ELECTRICAL POWER - ALTERNATOR CONTROL UNIT (ACU) AND CONNECTOR OBSOLESCENCE

SEB-24-06  
Page 1 of 8

This service document provides parts and instructions to remove and replace the alternator control unit and replace the airplane connector.

Figure 1. ACU Installation (Sheet 1)

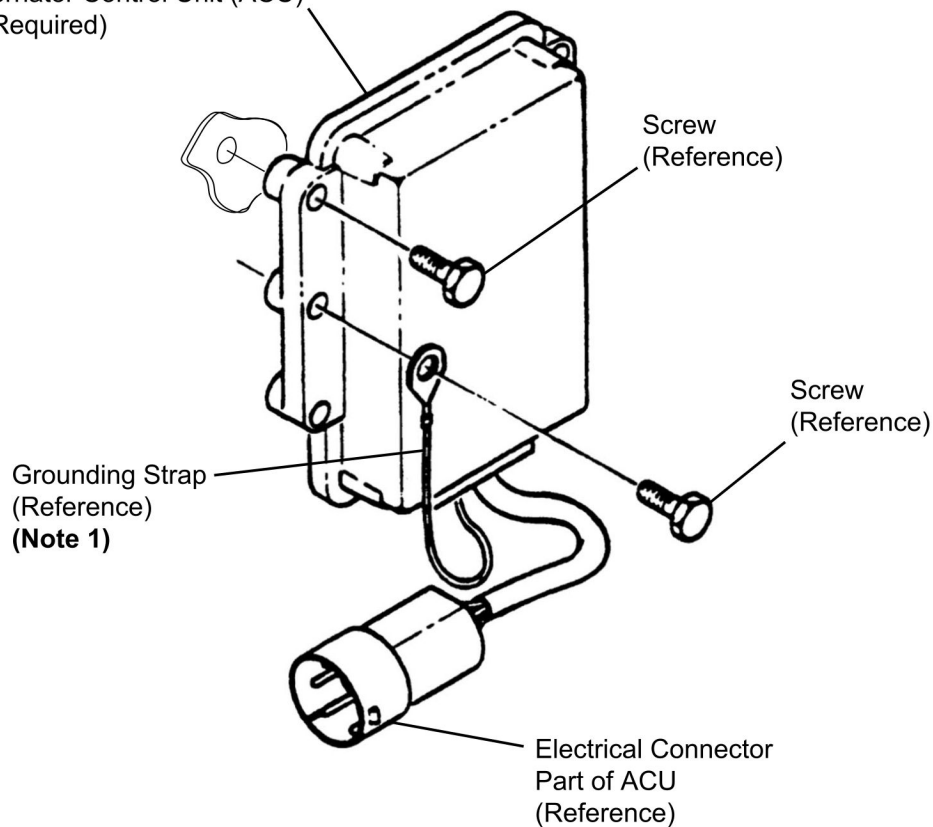
DGR3  
VR515F  
VR515GA  
Alternator Control Unit (ACU)  
(Discard)  
DGR3-5  
VR515F-5  
VR515GA-5  
Alternator Control Unit (ACU)  
(1 Required)

**NOTE 1:** The installation location of the ground strap may be different for each ACU. The ground strap from the new ACU needs to be installed in the same location when it was removed.

**NOTE:** The Alternator Control Unit (ACU) is installed on the forward side of the firewall on some models or is installed on the aft side of the firewall on other models.
3. Disconnect the Alternator Control Unit (ACU) electrical connector from aircraft electrical connector.
4. (Refer to Figure 1, Sheet 1.) Remove and keep the screw that attaches the grounding strap to the Alternator Control Unit (ACU) and aircraft structure.
  - A. Disconnect the grounding strap.
  - B. Record the installed position of the ground strap.

**NOTE:** DTM06-6S Electrical Connector only has 6 pins.
  - F. Install the WM-6S Wedge Lock.
  - G. Install 0413-204-2005 Sealing Plug in any unused pins in DTM06-6S Electrical Connector.
7. (Refer to Figure 1, Sheet 1.) Install the new Alternator Control Unit (ACU) as per Table 1 to the airplane with the kept screws.
8. Install the grounding strap to the Alternator Control Unit (ACU) and aircraft structure in the recorded position with the kept screw.

**NOTE:** The installation location of the ground strap may be different for each ACU. The ground strap from the new ACU needs to be installed in the same location when it was removed.
9. Remove the maintenance warning tags and connect the airplane battery.
10. (Refer to Figure 2, Sheet 1.) Connect the Alternator Control Unit (ACU) Electrical Connector to the DTM06-6S Aircraft Electrical Connector.
11. Install the removed access panels/doors. (Refer to applicable Service / Maintenance manuals - Section 11 - Engine.)
12. Do a "Before Takeoff" engine ground run to verify proper operation of the alternator and ACU. (Refer to the Pilot's Operating Handbook in Section 4 (Normal Procedures) and Section 7 (Systems Description).)

Figure 2. ACU Wiring Changes (Sheet 1)

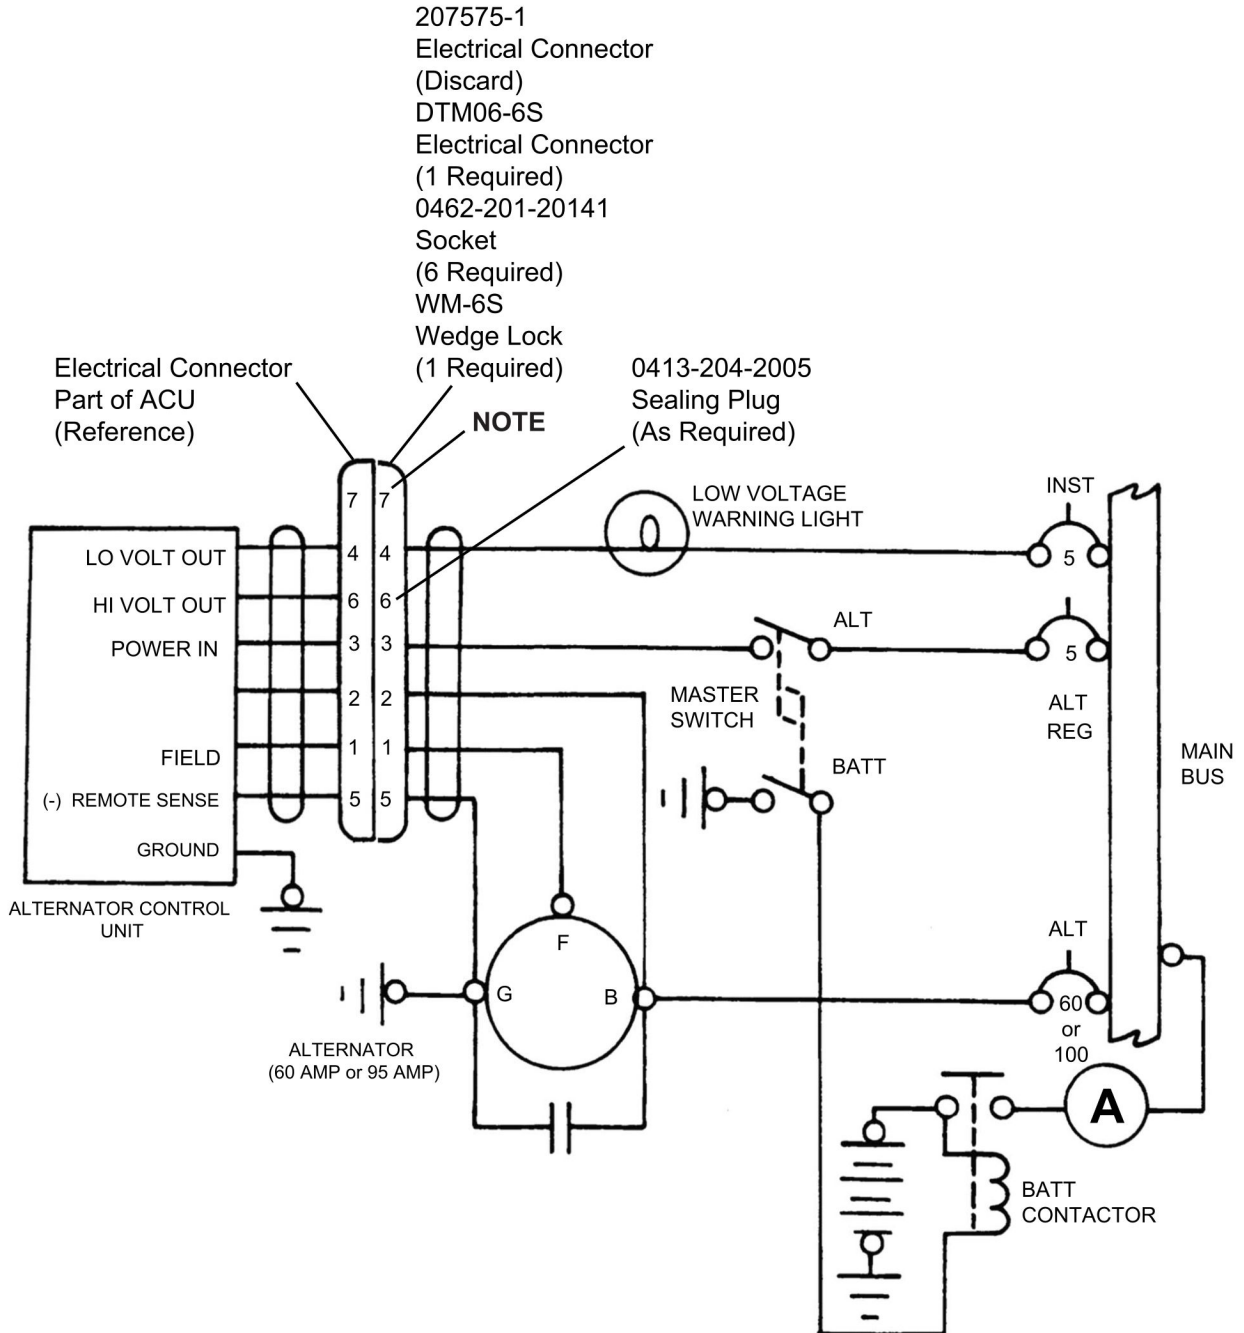
**NOTE:** Pin 7 of discarded ACU and discarded ship-side connector are unused. New ACU and ship-side connector only have 6 pins.

6. (Refer to Figure 2, Sheet 1.) Do the wiring modification as follows:
  - A. Tag and identify each wire with the pin number from the 207575-1 Electrical Connector.

**NOTE:** There should be no wire in pin 7.
  - B. Depin the wires from the electrical connector.
  - C. Remove and discard the 207575-1 Electrical Connector from the airplane.
  - D. Re-terminate each wire with 0462-201-20141 Sockets.
  - E. Pin the wires into the pin numbers identified in Step 6.A in the new DTM06-6S Electrical Connector.
